ADDENDUM TO ACP-2017-079 SHETLAND SPACE CENTRE LIMITED (SAXAVORD SPACEPORT) AIRSPACE CHANGE PROPOSAL CAP1616 STAGE 4B SUBMISSION

AMENDMENT TO PROPOSED AIRSPACE DESIGN

V1.0 FINAL 22 Sep 23

Figure 1, below, indicates the proposed amended Design Option. The proposed amendment airspace is depicted in red against Design Option 3.

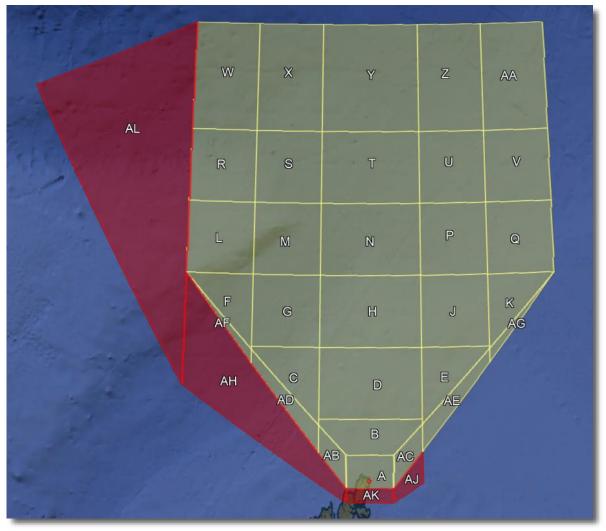
A small addition of approximately 6 nm has been made to the south of tile A, i.e. the "box" around the launch site; this amendment is tile "AK" in Figure 1.

Two additions have been made to support launch azimuths to the west: the first tile, "AH" in Figure 1, is suitable for both 330°T and 344°T launch azimuths; the second tile, "AL" in Figure 1, is suitable for 344°T launch azimuths.

Tile AL has not been extended to accommodate the 330°T azimuth immature LV case as SaxaVord considered that the required size of the amended airspace would be disproportionately large when it was not considered a likely immature LV launch azimuth.

One addition has been made, tile "AJ" in Figure 1. Although a northeasterly launch azimuth (such as 030°T) for an immature LV is considered unlikely, the addition of tile AJ would afford utility for cross range requirements for other launch azimuths in the immediate vicinity of the launch site. Tile AJ is comparable to tile AH but is truncated at the eastern boundary of the UK Flight Information Region.

To achieve any required individual safety clear zone at the spaceport (and, in turn, achieving safety by exclusion), the permanent DA would be sized 0.75nm radius centred on Launch Pad 2 (LP2) and 3,000ft Above Mean Sea Level (AMSL). LP2 is located near the centre of the SaxaVord launch area and is approximately equidistant from the spaceport's other 2 launch pads.
